PROPOSED SUBDIVISION FOR:  
**Habitat for Humanity  
 NW Metro Atlanta**

# Z-113-2016 GIS

**APPLICANT:** Habitat for Humanity of Northwest Metro Atlanta, Inc. **PETITION NO.:** Z-113

**PRESENT ZONING:** R-20 **PETITION FOR:** RA-5

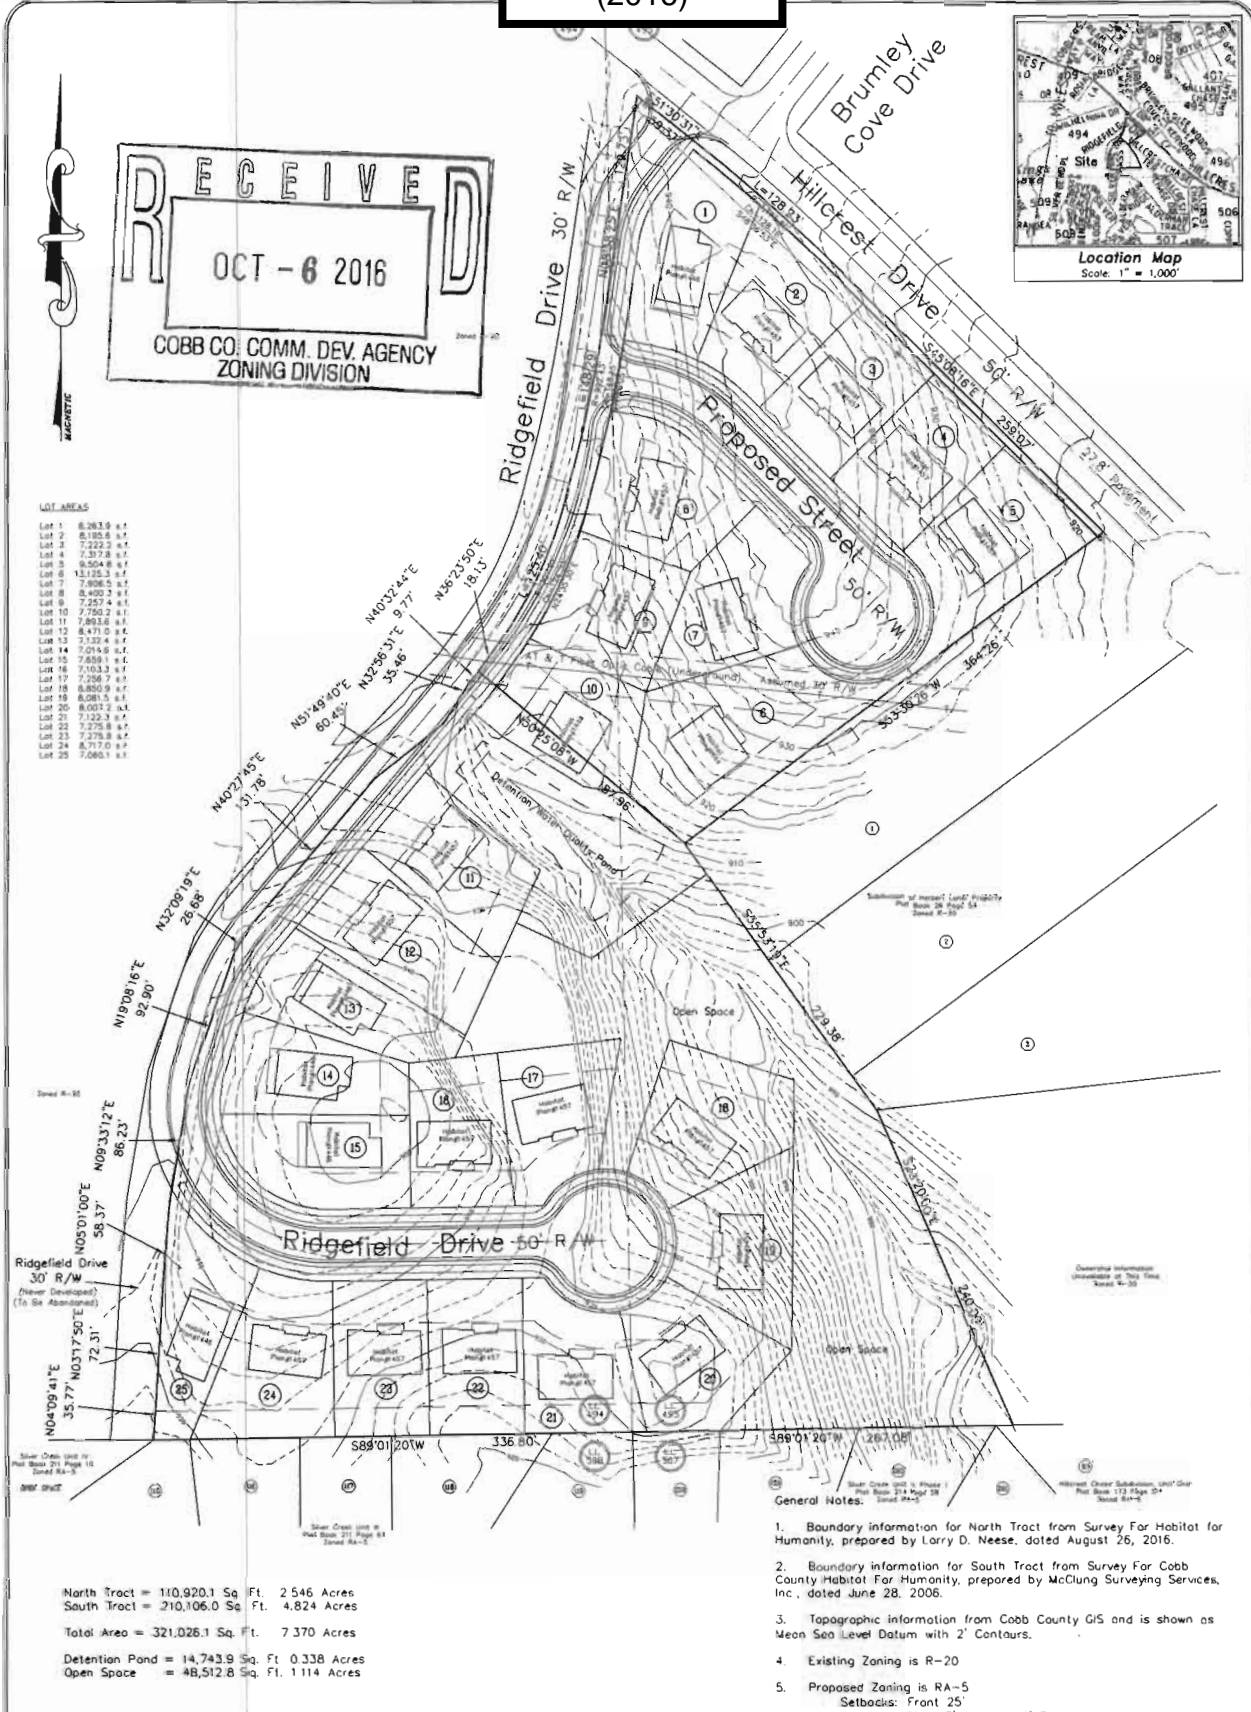
The proposed site plan will require a contemporaneous variance to waive the rear setback from the required 40 feet to 20 feet (the lots along Hillcrest Drive will continue to have a 40-foot rear setback).

**GUEST PARKING:** When projects contemplate less than 20 foot separation between units, guest parking shall be provided at a ratio of one-half space for each dwelling unit (1 space/2 units).

Size / Location of Existing Water Main(s): 6" DI / E side of Ridgefield Drive

Developer may be required to install/upgrade water mains, based on fire flow test results or Fire Department Code. This will be resolved in the Plan Review Process.

Approximate Distance to Nearest Sewer: Hillcrest Dr ROW, 120' W of SW corner of development

Additional Sewer easement likely required to serve southern lots. Northern lots may be served via  
Comments: Hillcrest Drive, depending on final elevations

- Provide comprehensive hydrology/stormwater controls to include development of out parcels.
- Submit all proposed site improvements to Plan Review.
- Any **spring activity** uncovered must be addressed by a qualified geotechnical engineer (PE).
- Structural fill \_\_\_\_\_ must be placed under the direction of a qualified registered Georgia geotechnical engineer (PE).
- Existing facility.
- Project must comply with the Water Quality requirements of the CWA-NPDES-NPS Permit and County Water Quality Ordinance.
- Water Quality/Quantity contributions of the existing lake/pond on site must be continued as baseline conditions into proposed project.
- Calculate and provide % impervious of project site.
- Revisit design; reduce pavement area to reduce runoff and pollution.

- No Stormwater controls shown \_\_\_\_\_
- Copy of survey is not current – Additional comments may be forthcoming when current site conditions are exposed.
- No site improvements showing on exhibit.

1. This site is located just south of Hillcrest Drive and east of Ridgefield Drive. The site is wooded with slopes ranging from approximately 5% near the ridgelines to 50% within the ravine that runs through the center of the site. The stream that traverses the site is identified on the County’s Stream Buffer Map as having a 50-foot undisturbed buffer. This will need to be verified since it will dictate the location of the proposed stormwater management facility. It will also impact the viability of lots 10, 11 & 18.

Recommend curb and gutter along both sides and sidewalk along one side of proposed development roadway.

Recommend curb, gutter, and sidewalk along the frontage of Ridgefield Drive and Hillcrest Drive.

Ridgefield Drive is a substandard street. Recommend improving Ridgefield Drive from along the frontage to the intersection with Hillcrest Drive to comply with Cobb County Standards.

Recommend a no access easement along the Hillcrest Drive frontage.

Recommend development street either directly align or have an offset of a minimum of 125 feet from Brumley Cove Drive per Development Standard 401.10.

1. Site plan received by the Zoning Division on October 6, 2016, with the District Commissioner approving minor modifications;
2. Variance mentioned in the Zoning Comments section;
3. Fire Department comments and recommendations;
4. Water and Sewer Division comments and recommendations;
5. Stormwater Management Division comments and recommendations;
6. Department of Transportation comments and recommendations; and
7. Owner/developer to enter into a Development Agreement pursuant to O.C.G.A. §36-71-13 for dedication of system improvements to mitigate traffic concerns.
